**TOWN OF MOUNTAIN VILLAGE
REGULAR DESIGN REVIEW BOARD MEETING
THURSDAY DECEMBER 7, 2017 10:00 AM
2nd FLOOR CONFERENCE ROOM, MOUNTAIN VILLAGE TOWN HALL
455 MOUNTAIN VILLAGE BLVD, MOUNTAIN VILLAGE, COLORADO
AGENDA**

TO: Design Review Board
FROM: Dave Bangert, Senior Planner
FOR: Meeting of December 7, 2017
DATE: November 29, 2017
RE: Final Design Review application for a new single-family dwelling on Lot 702

TO: Design Review Board
FROM: Dave Bangert, Senior Planner
FOR: Meeting of December 7, 2017
DATE: November 29, 2017
RE: Conceptual work session for a new single-family dwelling on Lot 359, 115 Snowfield Dr.

TO: Design Review Board
FROM: Dave Bangert, Senior Planner
FOR: Meeting of December 7, 2017
DATE: November 29, 2017
RE: Conceptual work session for a new single-family dwelling on Lot 89-2B, 667 Mountain Village Blvd.

2 ENLARGED - ENTRY PLAN HIGH
1/4" = 1'-0"

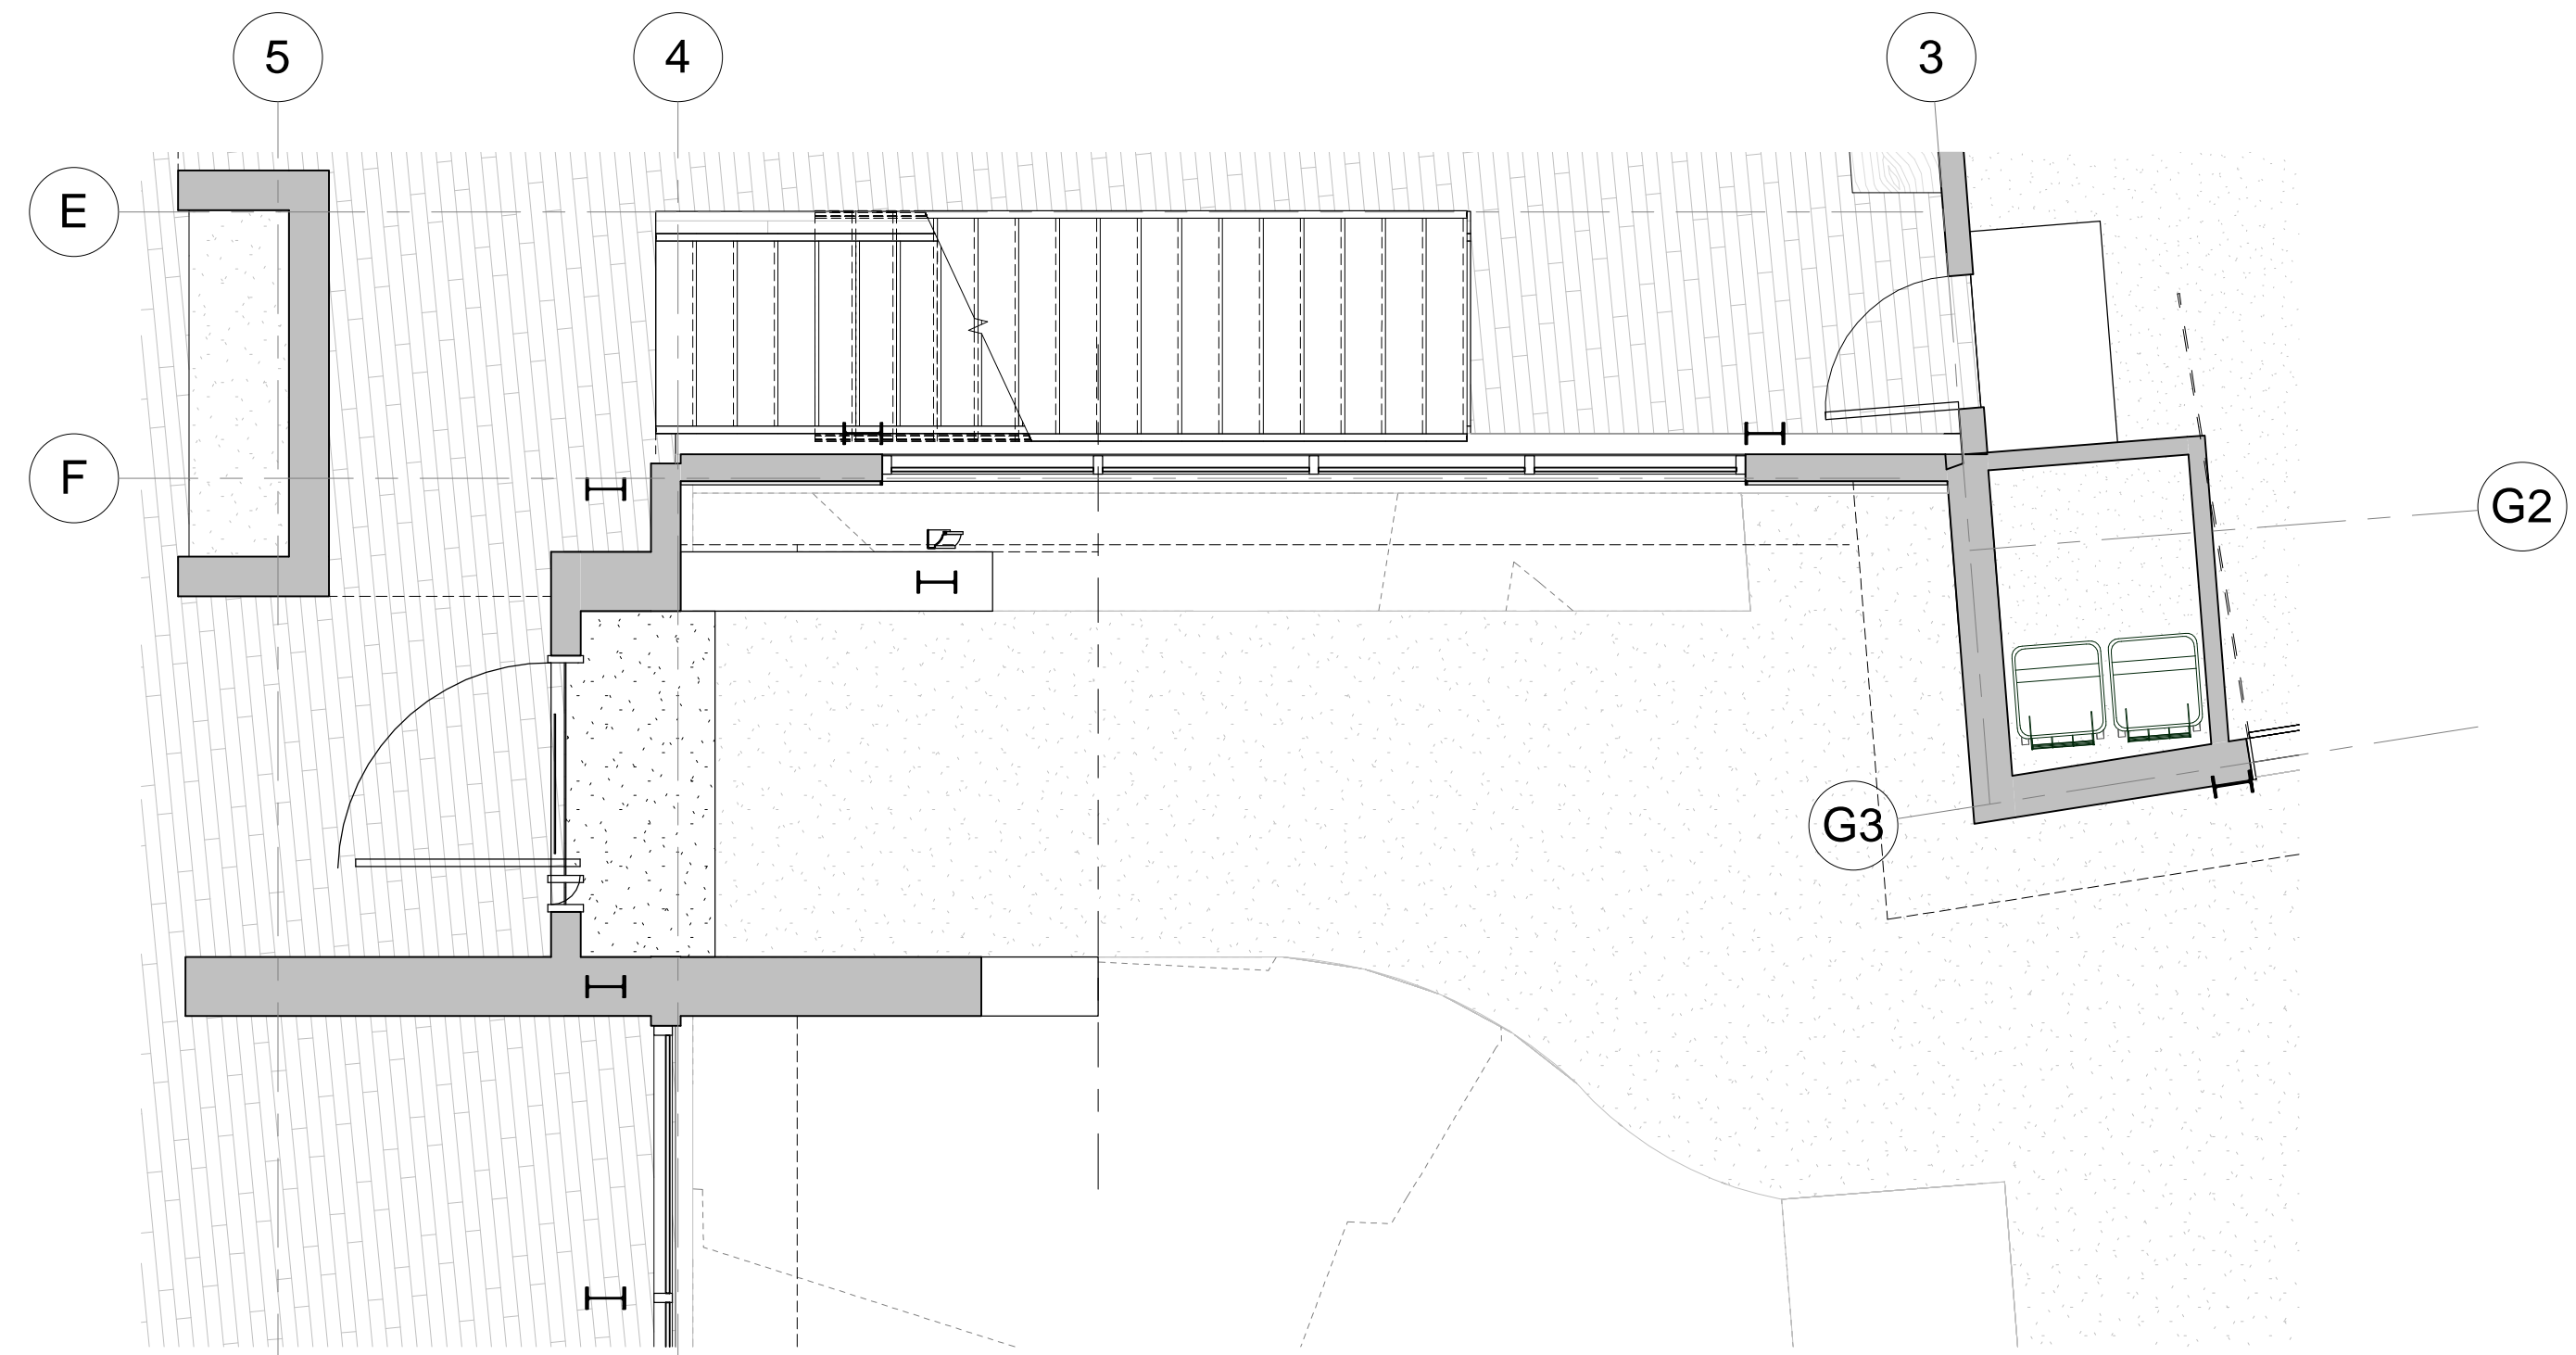
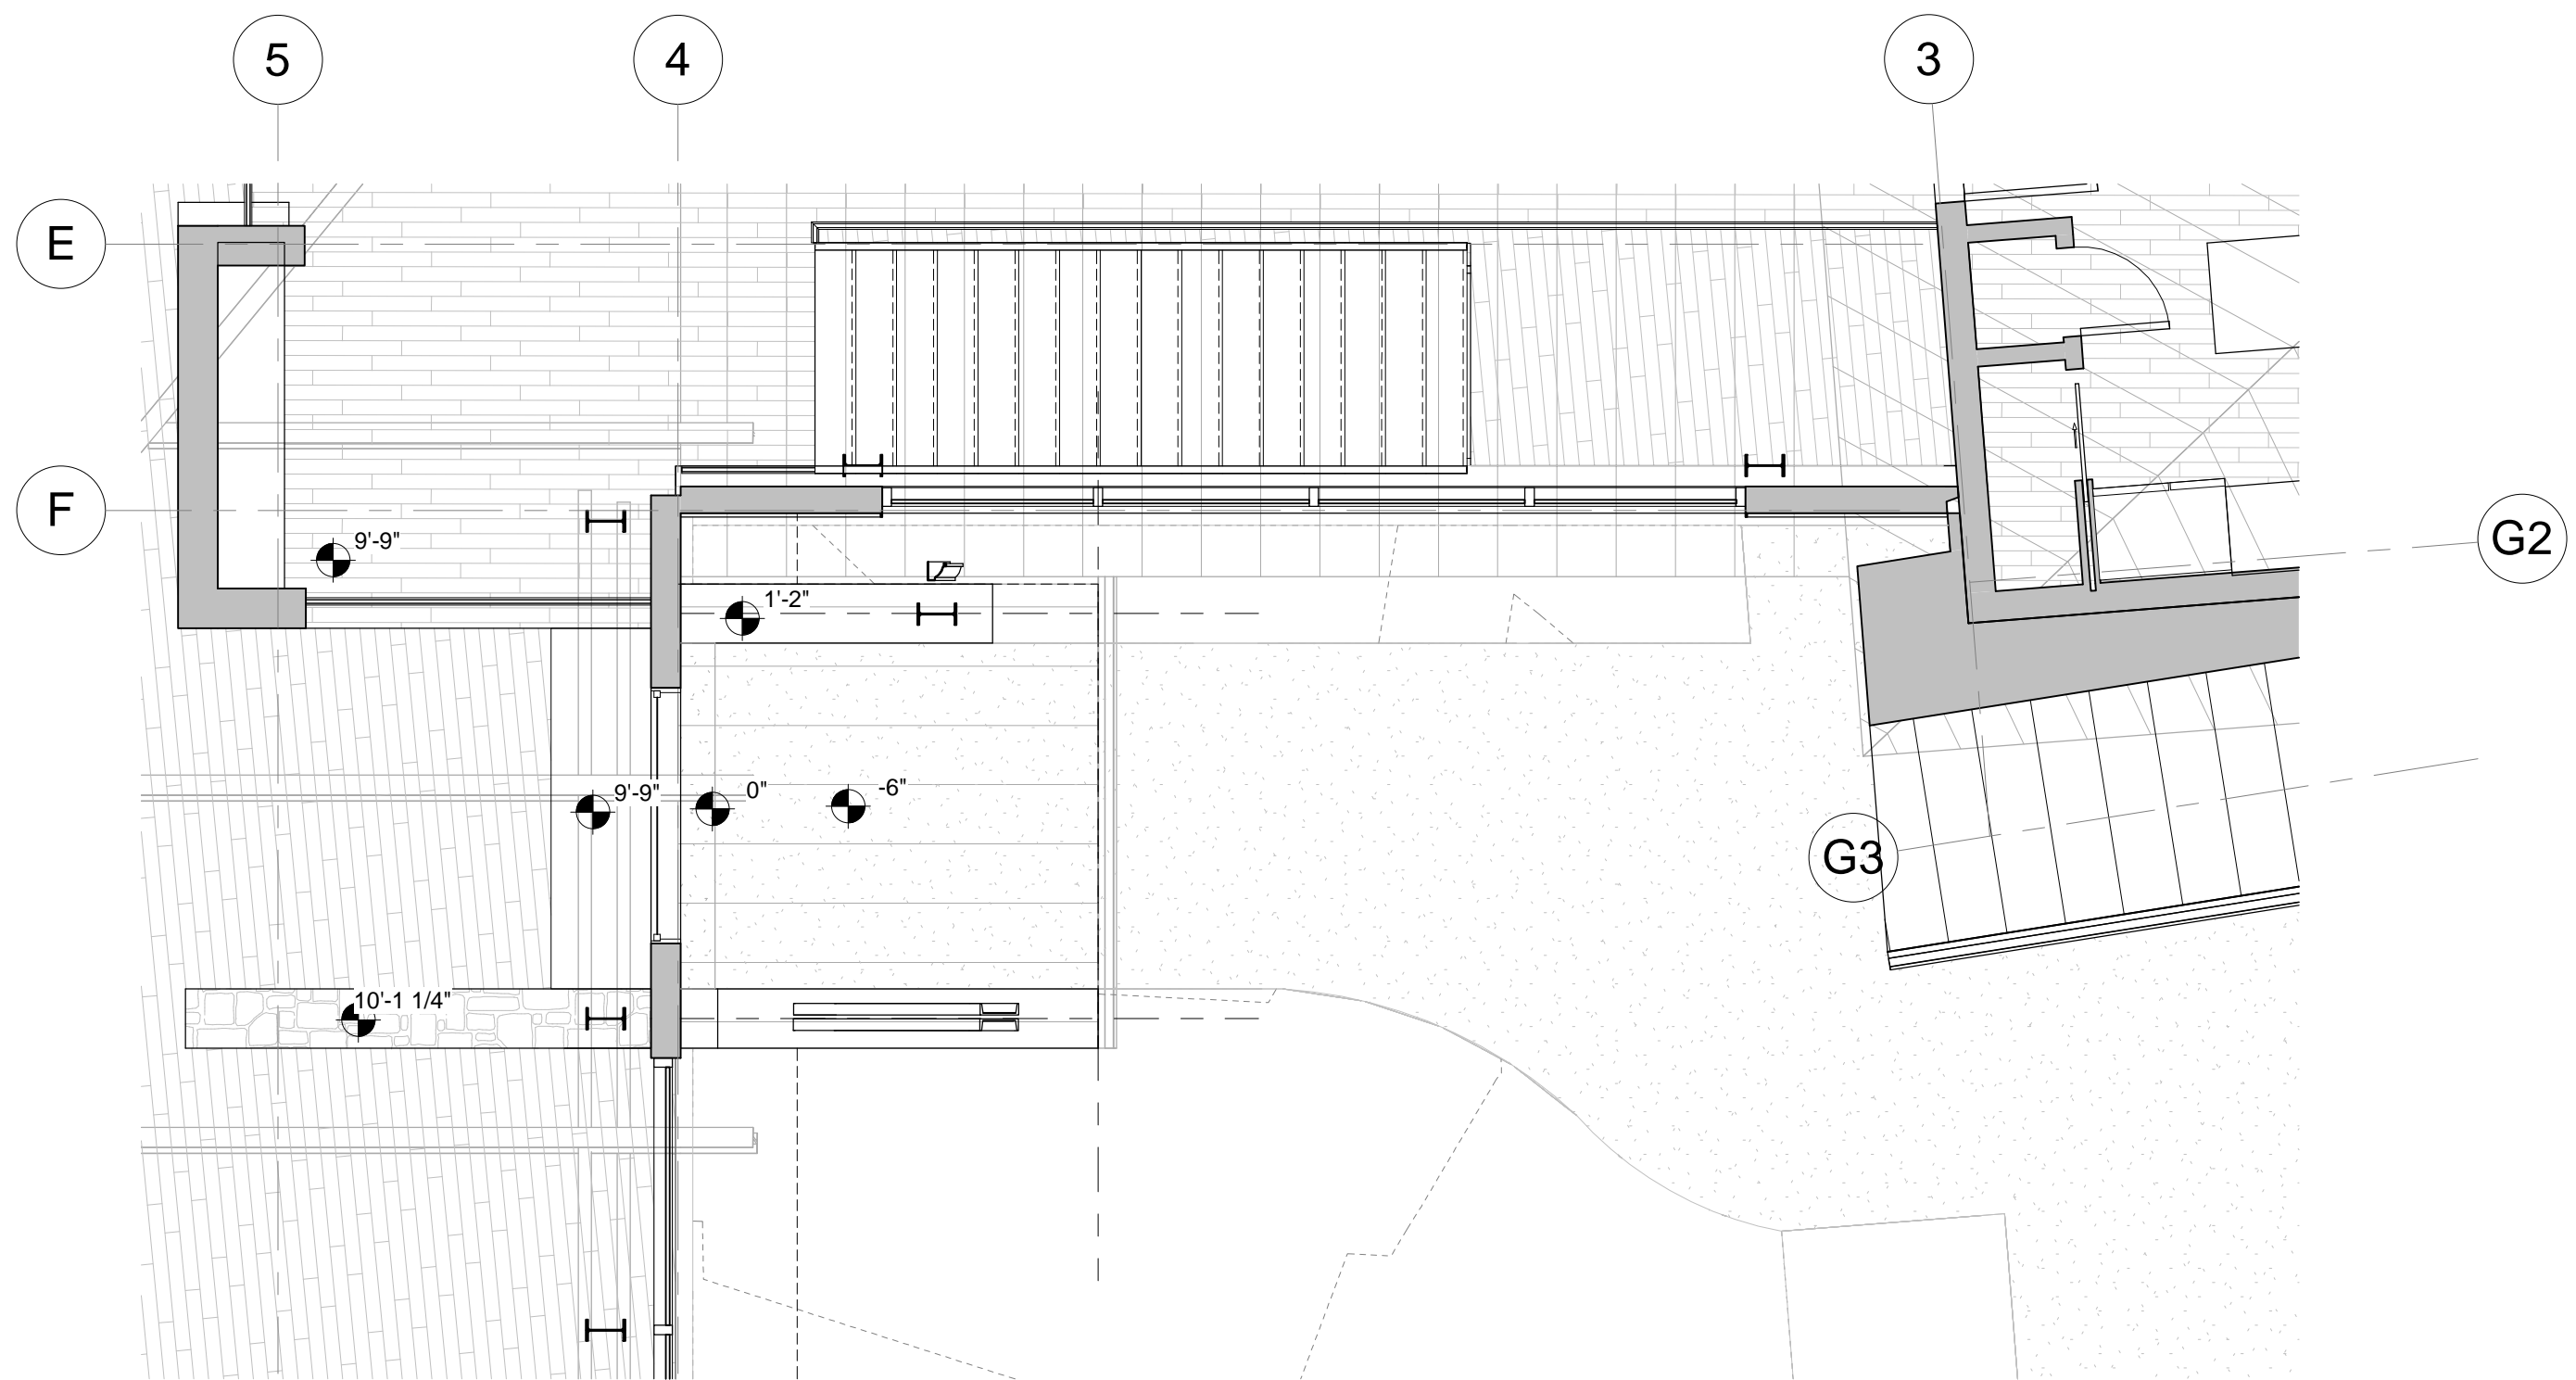
- Roof pitches have been increased to 1.5:12 in some locations.
- Increased mechanical space and small shed roof form on our main chimney space at grade on west elevation
- Revised front entry design with taller front stone wall continuous to the inside space – one noted vertical steel column on the east which hides a downspout
- Heated and hard surface primary deck has been included to exterior heat melt calculations
- Lighting cut sheets and exterior lighting clarifications
- Revised lighting at address monument
- Light spill – we are proposing internal shades with a '2 step' function to filter light from the main living space – Ref. dwg #1/A202.
